RECOGNITION CATEGORY
ABNORMAL RAD LEVELS / RADIOLOGICAL EFFLUENTS

ARG1

Initiating Condition:

Release of gaseous radioactivity resulting in offsite dose greater than 1000 mRem TEDE or 5000 mRem thyroid CDE.

RECOGNITION CATEGORY
FISSION PRODUCT BARRIER DEGRADATION
Figure 93-F-41: PWR Containment Integrity or Bypass Examples

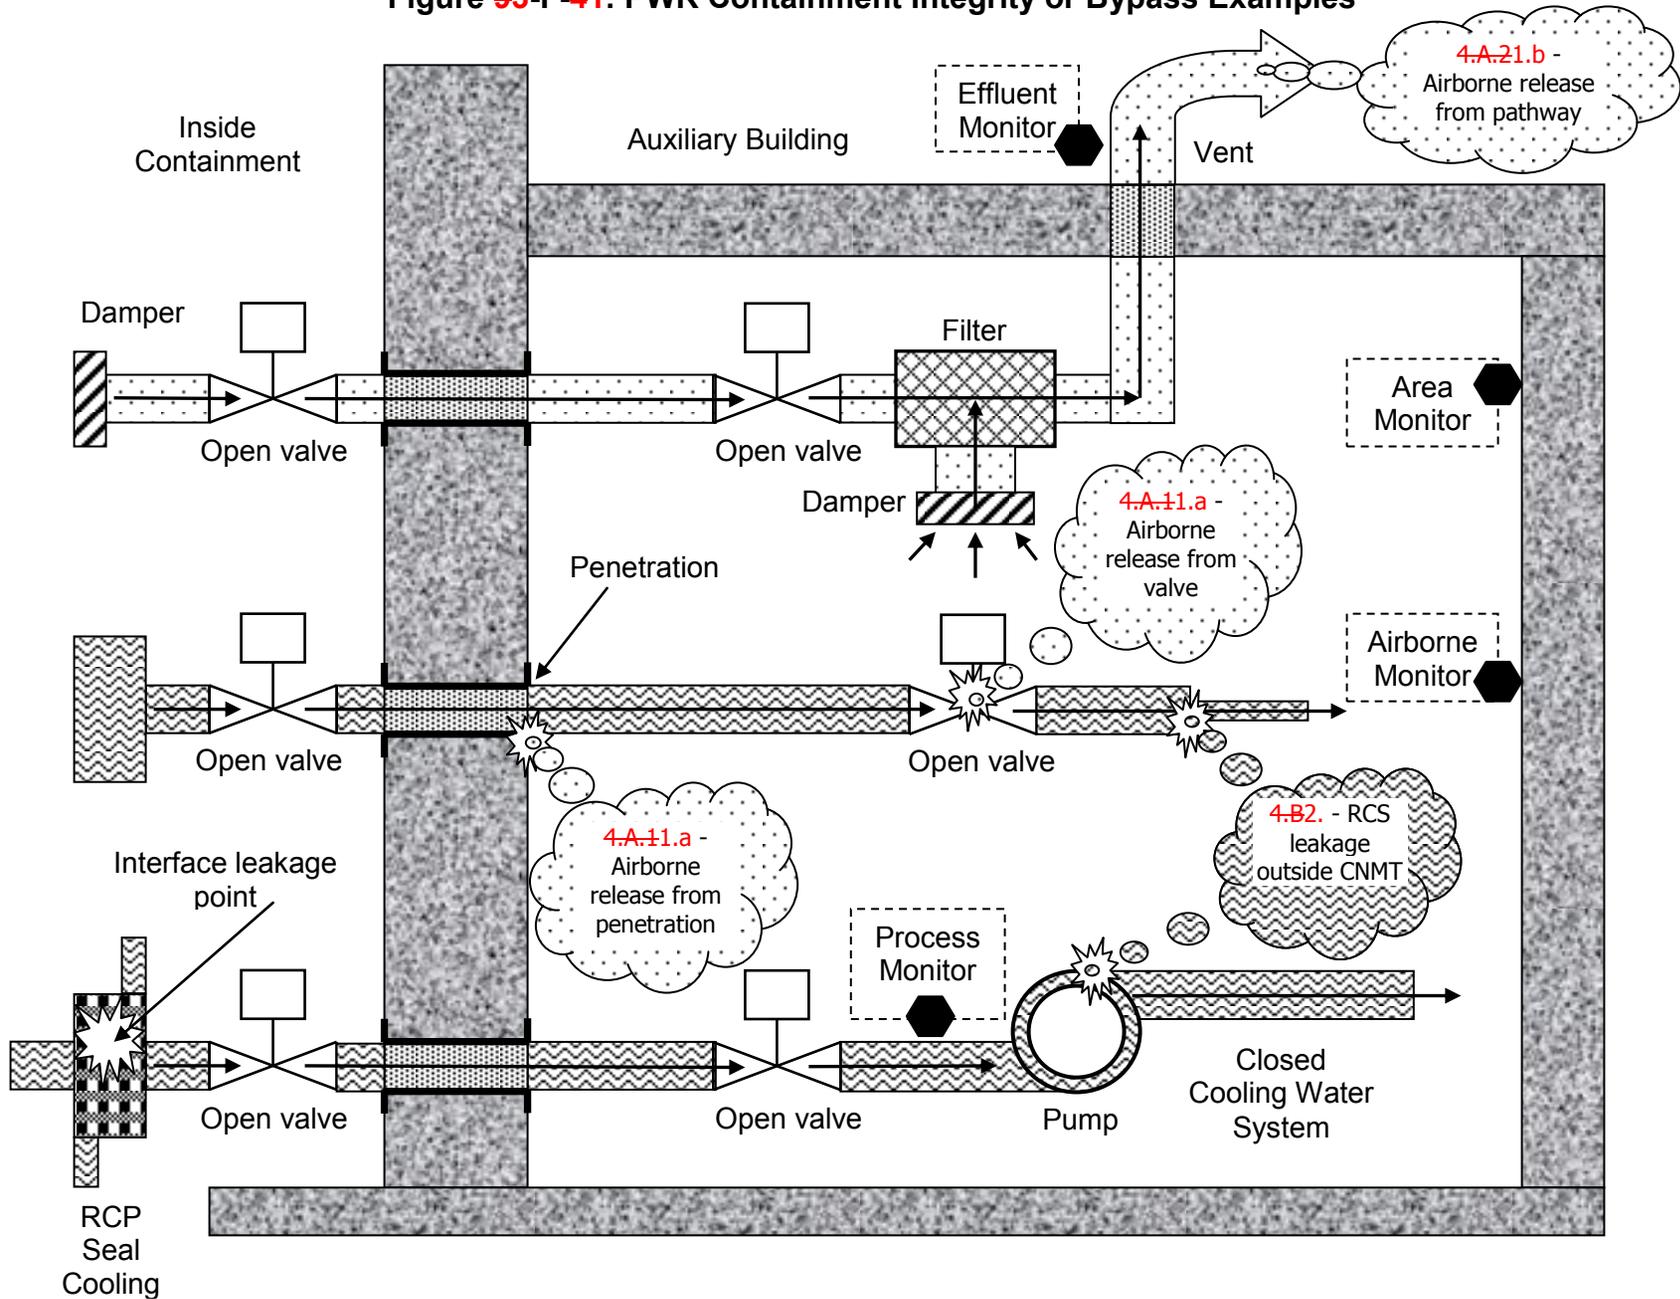
Refer to the middle piping run of Figure 9-F-4. Two simplified examples are provided. One is leakage from a penetration and the other is leakage from an in-service system valve. Depending upon radiation monitor locations and sensitivities, the leakage could be detected by any of the four monitors depicted in the figure.

Refer to the top piping run of Figure 9-F-4. In this simplified example, the inboard and outboard isolation valves remained open after a containment isolation was required (i.e., containment isolation was not successful). There is now an UNISOLABLE pathway from the containment to the environment.

Refer to the bottom piping run of Figure 9-F-4. In this simplified example, leakage in an RCP seal cooler is allowing radioactive material to enter the Auxiliary Building. The radioactivity would be detected by the Process Monitor. If there is no leakage from the closed water cooling system to the Auxiliary Building, then no threshold has been met. If the pump or system piping developed a leak that allowed steam/water to enter the Auxiliary Building, then **loss** threshold **24.B** would be met. Depending upon radiation monitor locations and sensitivities, this leakage could be detected by any of the four monitors depicted in the figure and cause threshold **1.a4.A.1** to be met as well.

Refer to the middle piping run of Figure 9-F-4. In this simplified example, a leak has occurred at a reducer on a pipe carrying reactor coolant in the Auxiliary Building. Depending upon radiation monitor locations and sensitivities, the leakage could be

detected by any of the four monitors depicted in the figure and cause ~~loss~~ threshold ~~1.a4.A.1~~ to be met as well.
